HISTORIC AND DESIGN REVIEW COMMISSION

November 16, 2022

HDRC CASE NO: 2022-399
ADDRESS: 363 NORTH DR
LEGAL DESCRIPTION: NCB 7026 BLK 5 LOT 16, E11 FT OF 18
ZONING: R-6, H
CITY COUNCIL DIST.: 7
DISTRICT: Monticello Park Historic District
APPLICANT: Thomas Gandy/GANDY THOMAS R
OWNER: Thomas Gandy/GANDY THOMAS R
TYPE OF WORK: Exterior modifications, fenestration modifications
APPLICATION RECEIVED: July 24, 2022
60-DAY REVIEW: Not applicable due to City Council Emergency Orders
CASE MANAGER: Edward Hall

A-10

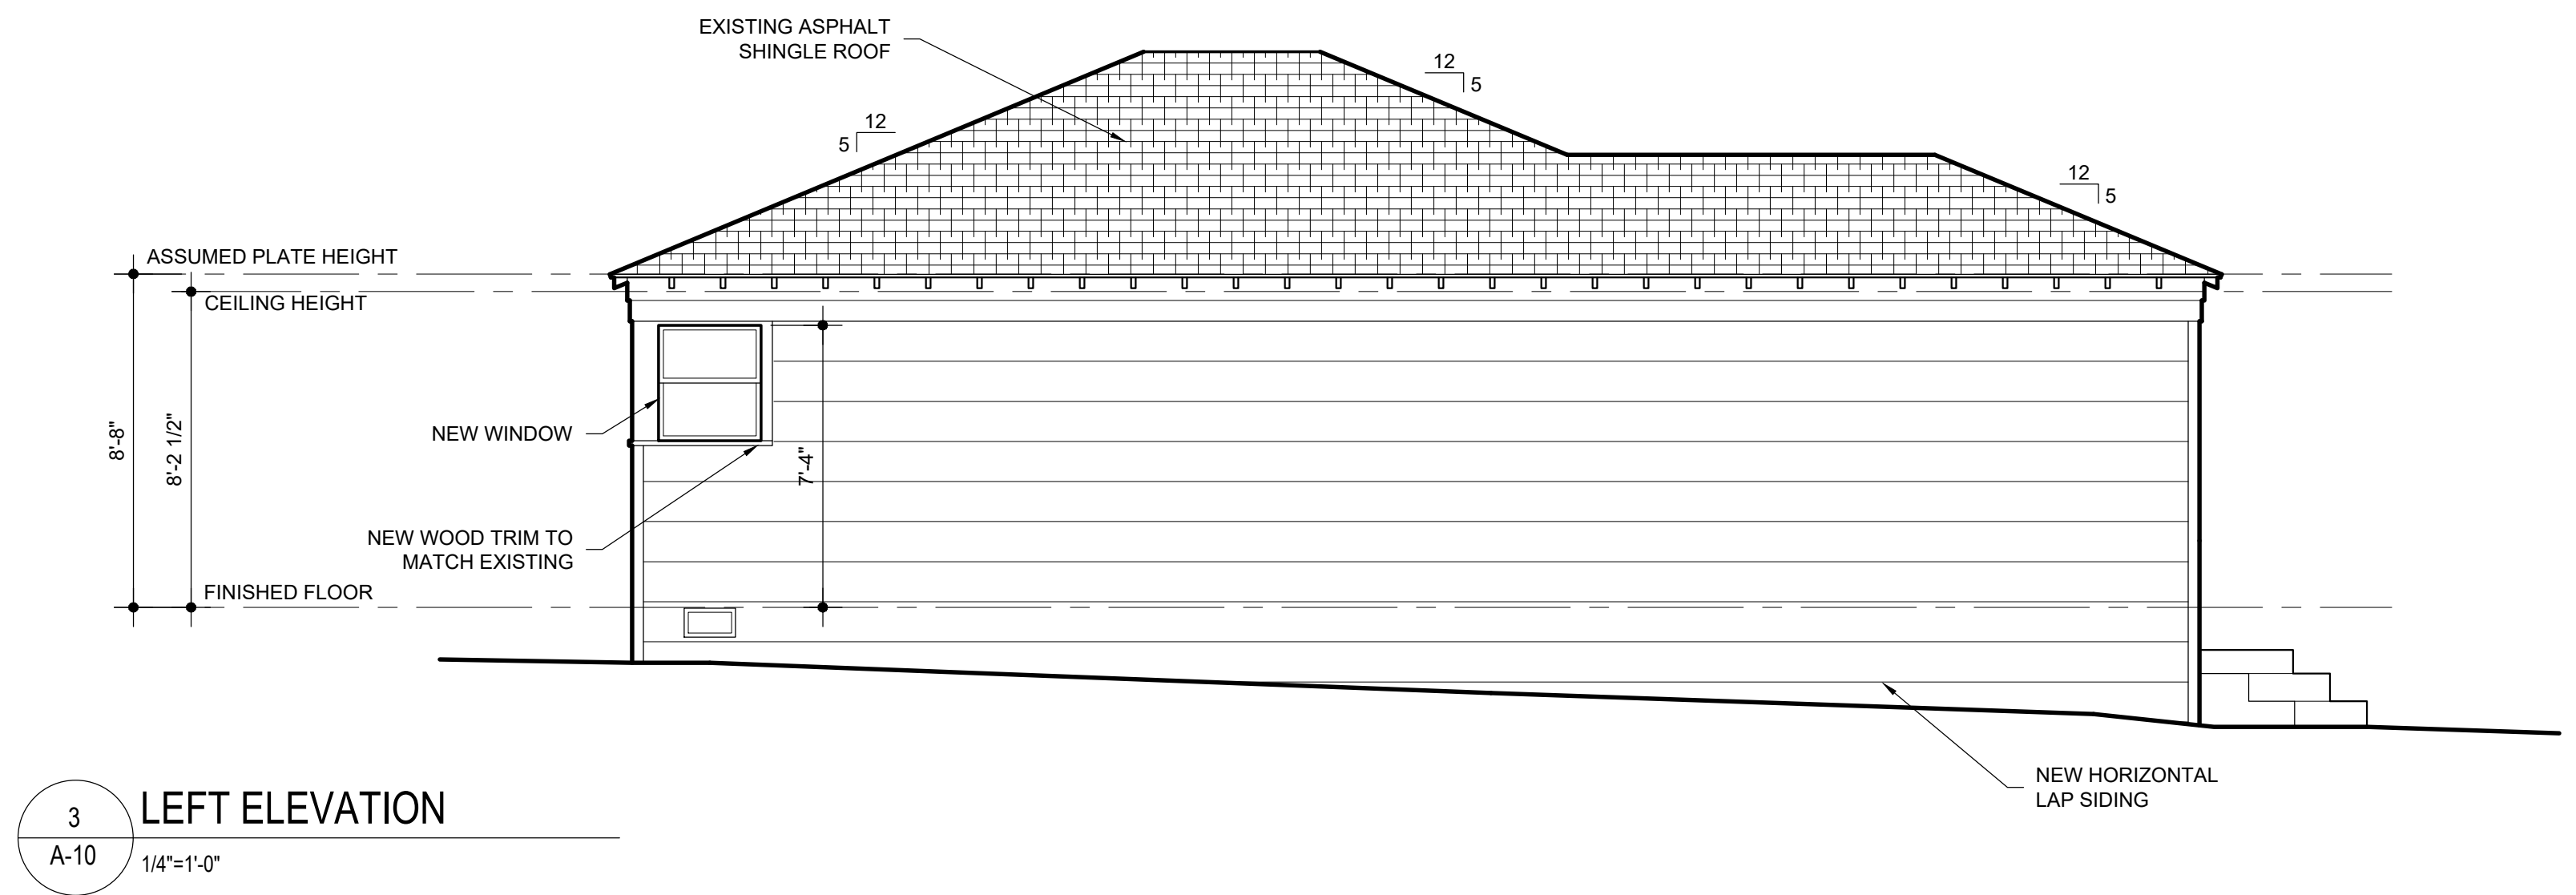
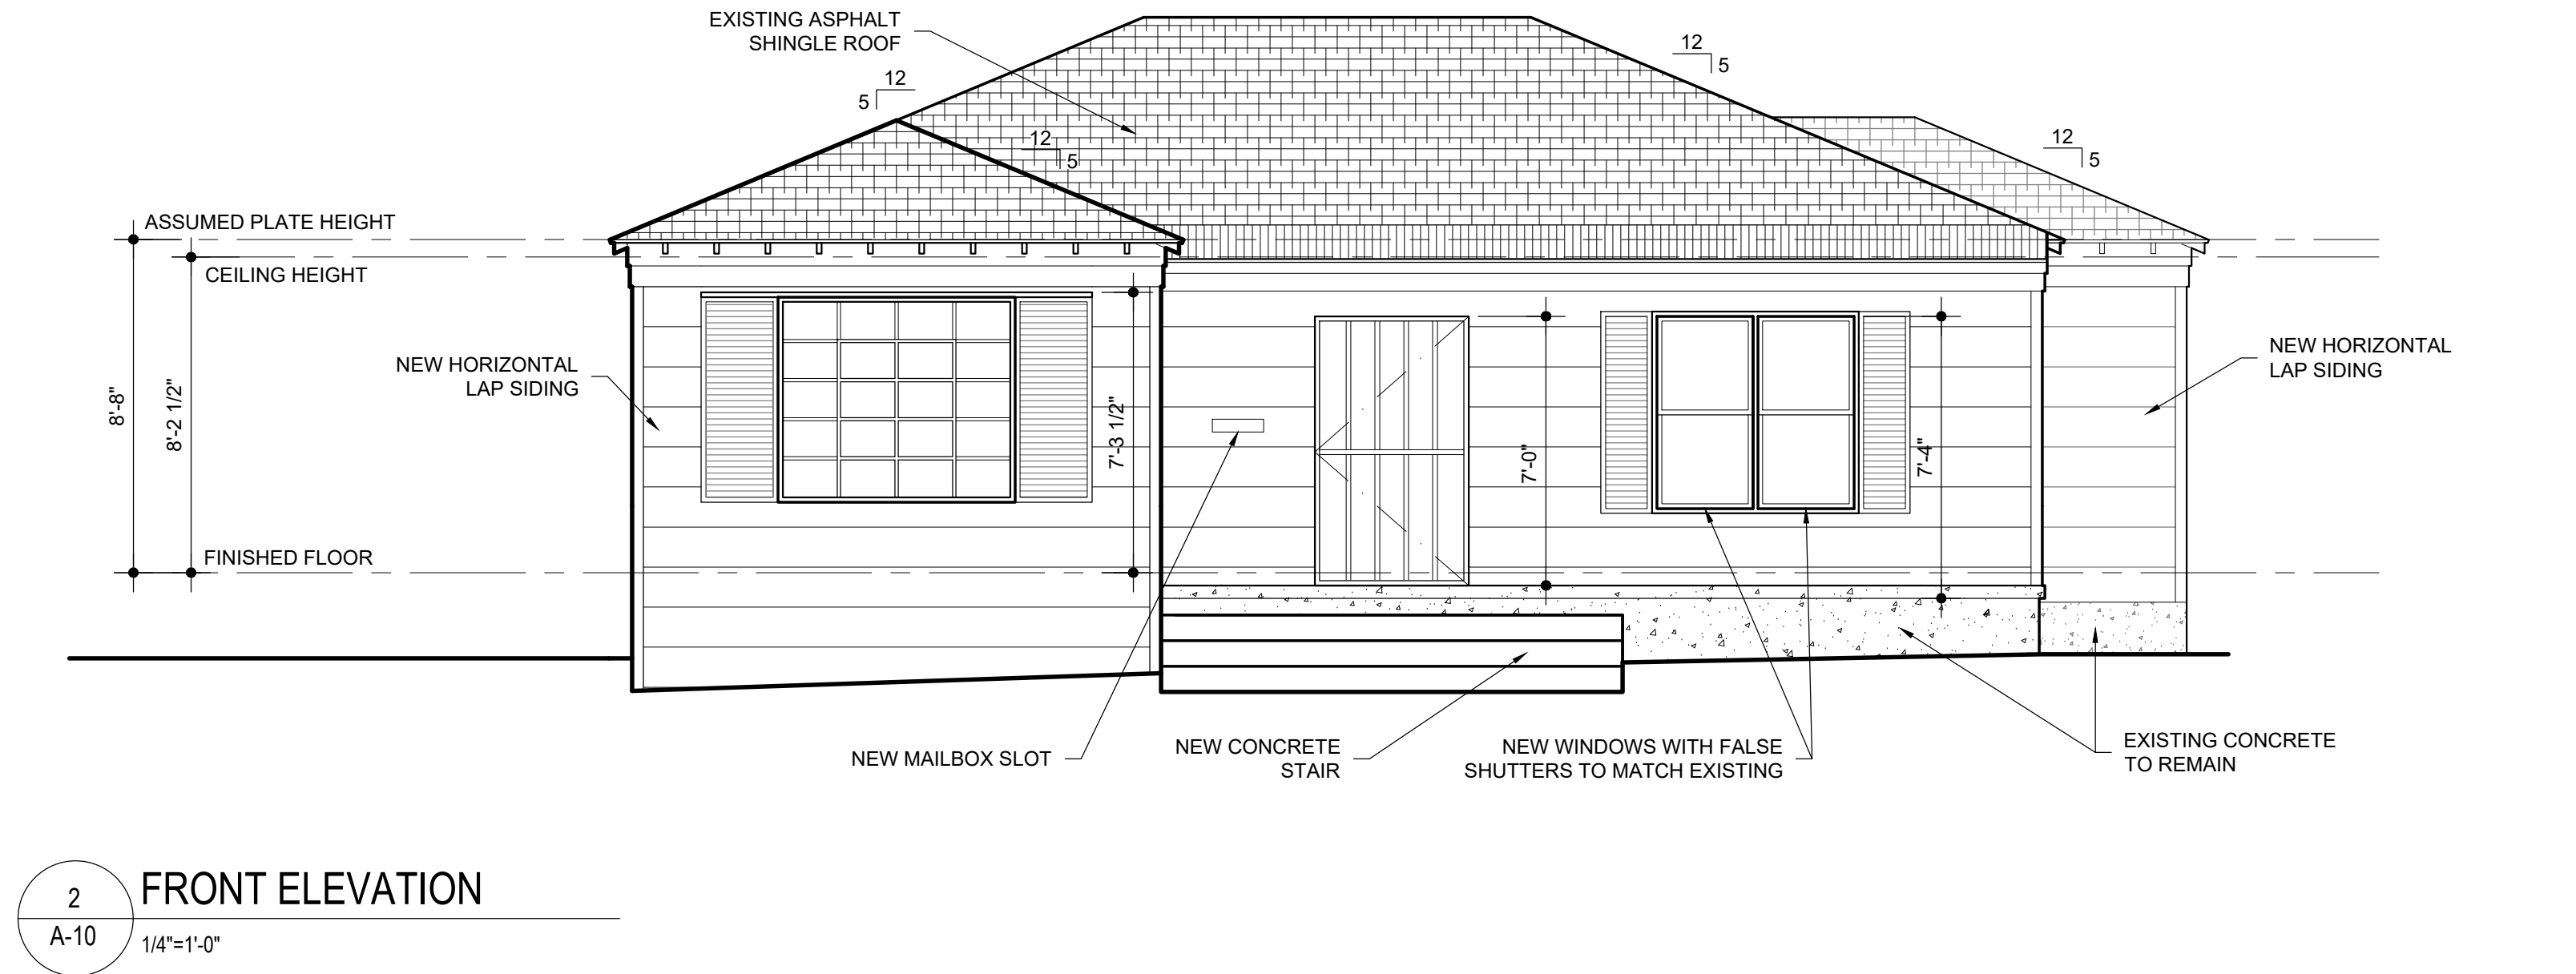
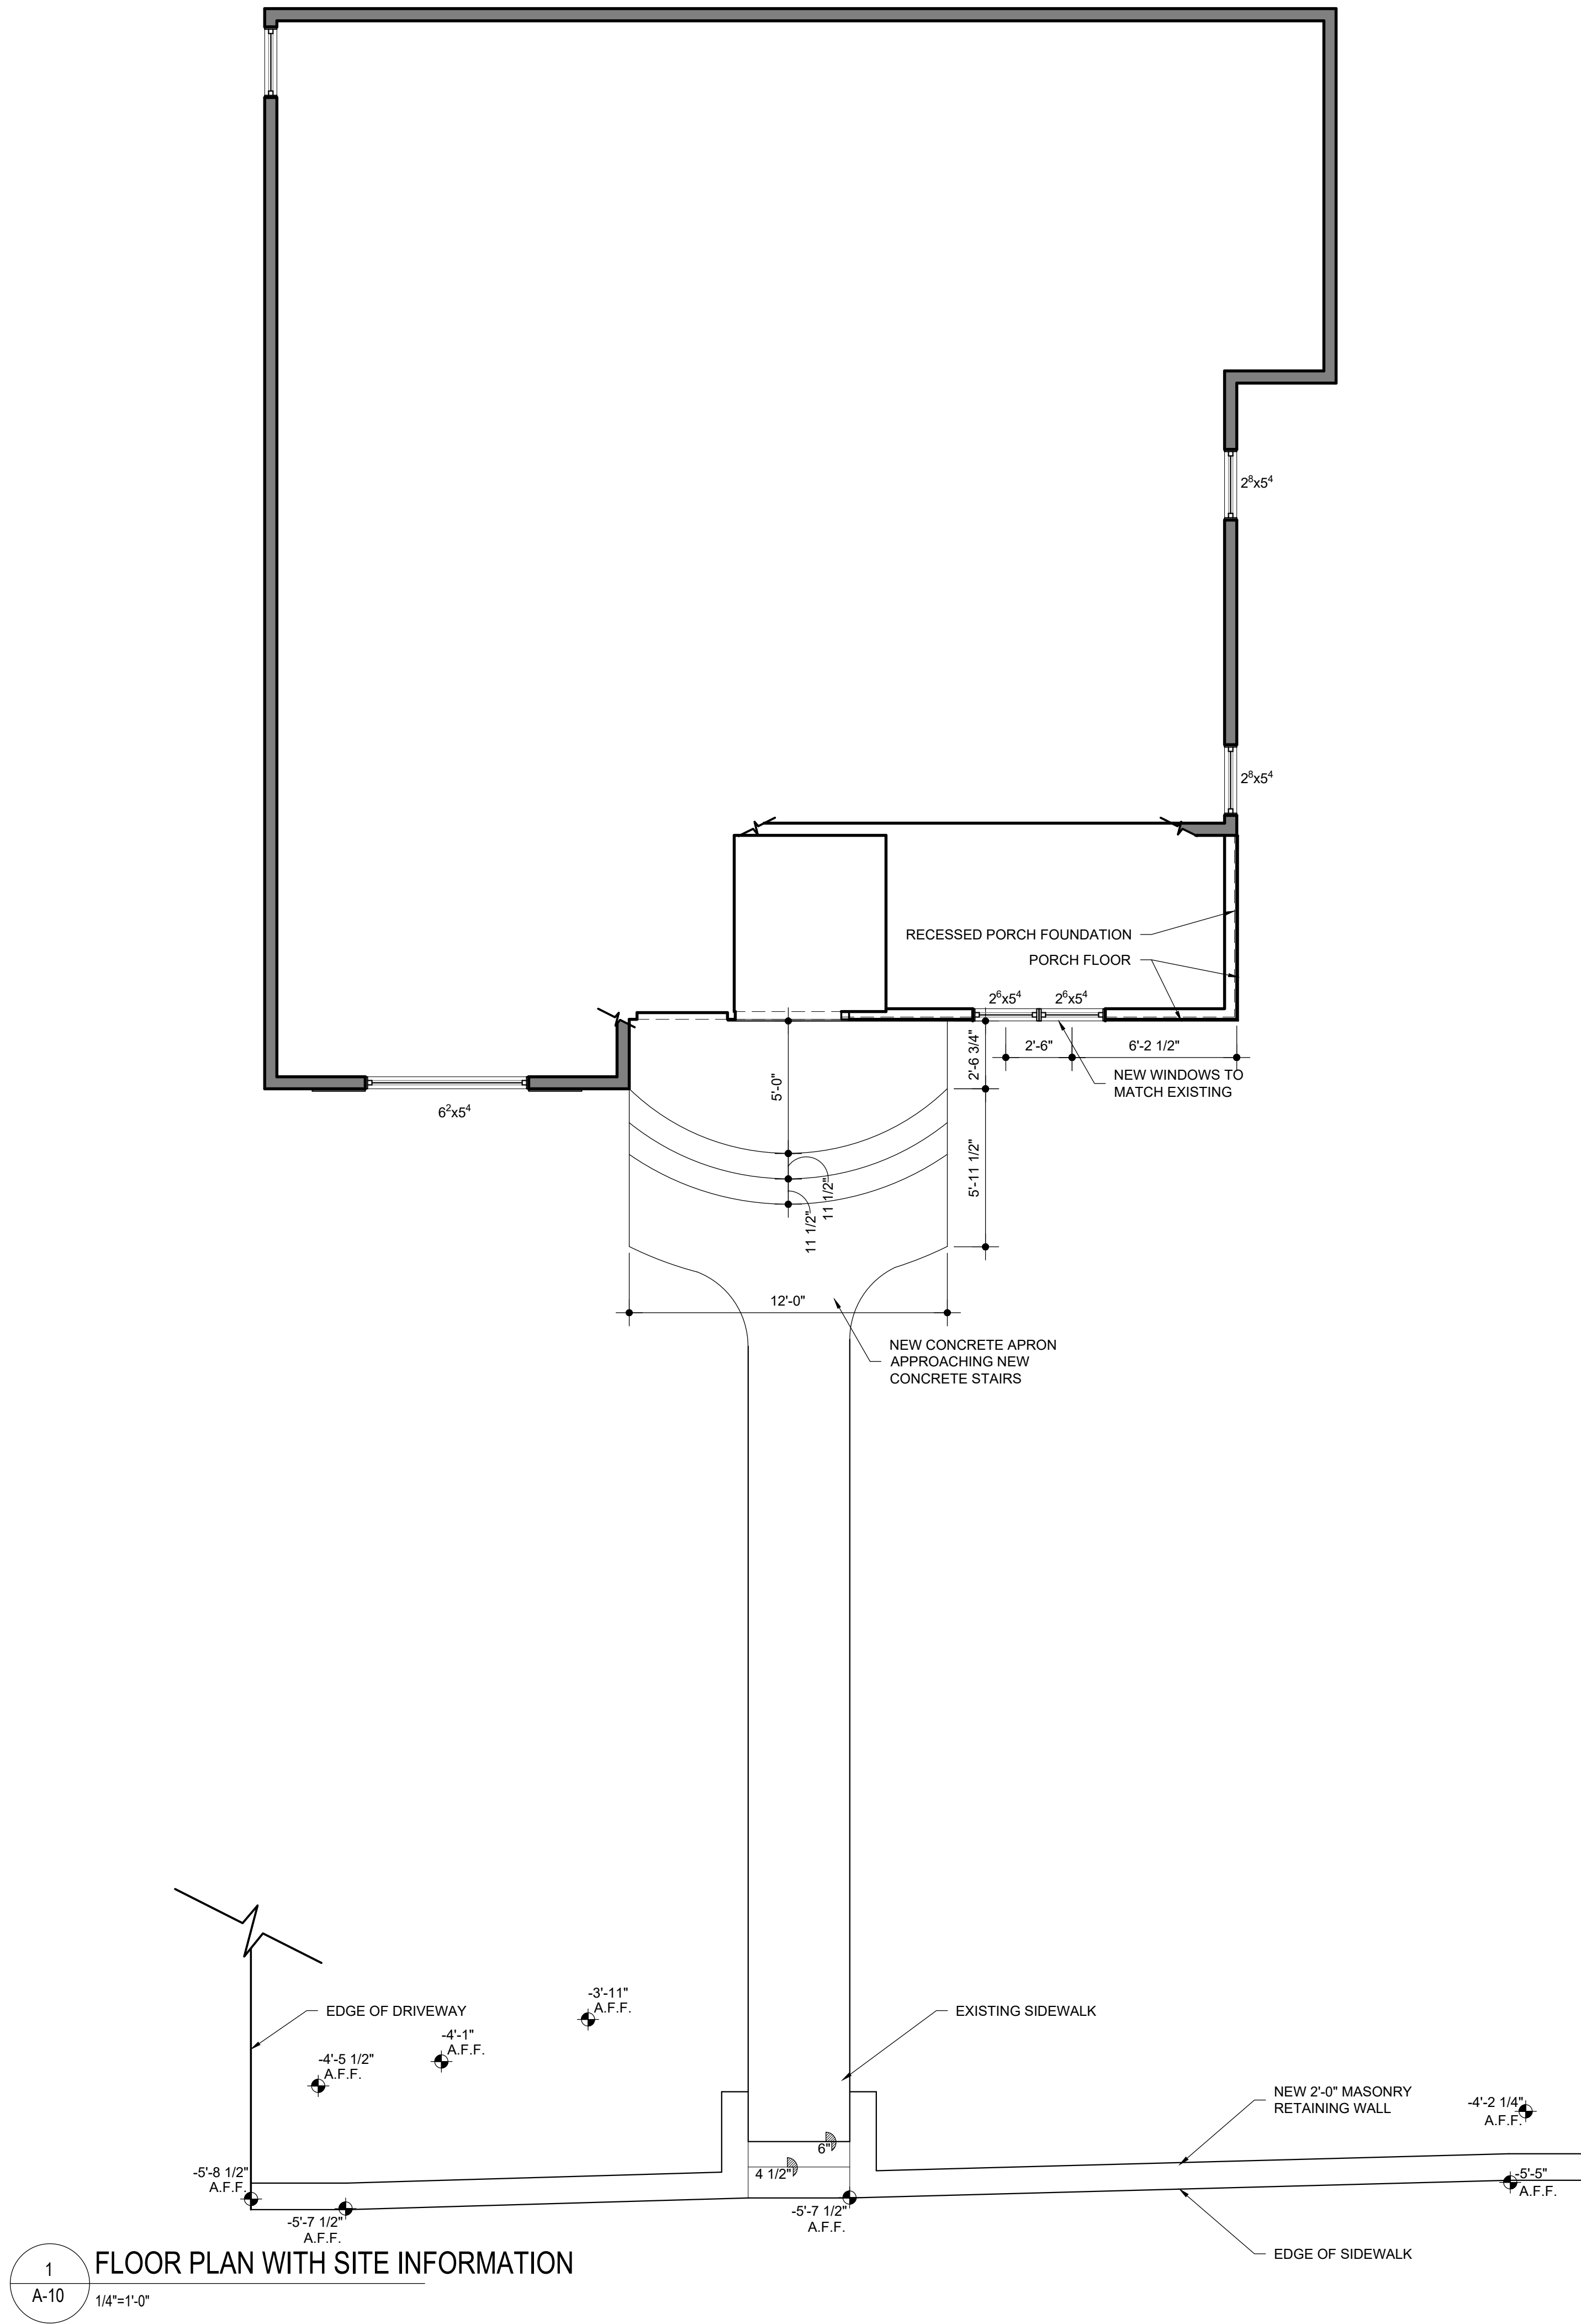
- e. SIDING INSTALLATION – The applicant has proposed to remove the existing façade tiles and brick wainscoting and install horizontal lap siding on each façade. Per the 1941 Sanborn Map, the structure originally features asbestos tiles. Staff finds the removal of asbestos tiles to be appropriate; however, a replacement tile should be installed that preserved the existing profile and appearance of the tiles siding. Many structures of similar form and style found on this block feature masonry (brick or stone) wainscoting. Staff finds the brick wainscoting to be original and finds that it should be preserved.

- f. EXTERIOR MODIFICATIONS (Front Façade) – The applicant has proposed to perform modifications to the front façade to include the installation of two, one over one windows on the front façade. This wall plane is not original and is the front of a previously enclosed front porch. The Guidelines for Exterior Maintenance and Alterations 7.A and B. note that front porches should not be enclosed. When porches are enclosed, the Guidelines note that they should function and visible read as a porch. Per photos, the front porch has been enclosed with screening elements since 2007, at least. Staff finds that either windows should be added across the entirety of the enclosed porch to read as an open element with visible porch columns, or that the structure should be returned to its previous condition.

- h. FRONT PORCH STEPS – The applicant has proposed to install new, rounded concrete porch steps as well as a concrete apron to the proposed porch steps. The existing steps are clad in brick, but feature a minimal design and a width that is slightly wider than that of a pedestrian door opening. There is no historic precedent of an alternative porch design on site or within the district. Staff finds that the existing porch steps form should be maintained. In-kind replacement, with concrete would be appropriate, with no change to profile.

1. Staff does not recommend approval of item #1, the removal of the existing façade tiles and brick wainscoting for the installation of lap siding as noted in finding e. Staff recommends that the existing siding tile profile be maintained. Replacement with a fiber cement tile with matching profile would be appropriate and eligible for administrative approval.

2. Staff does not recommend approval of item #2, modifications to the front façade, as noted in finding f. Staff recommends that either windows be added across the entirety of the enclosed porch to read as an open element with visible porch columns or that the structure be returned to its previous condition.

4. Staff does not recommend approval of item #4, the installation of new, rounded concrete porch steps and a concrete apron as noted in finding h. In-kind replacement, with concrete would be appropriate, with no change to profile.
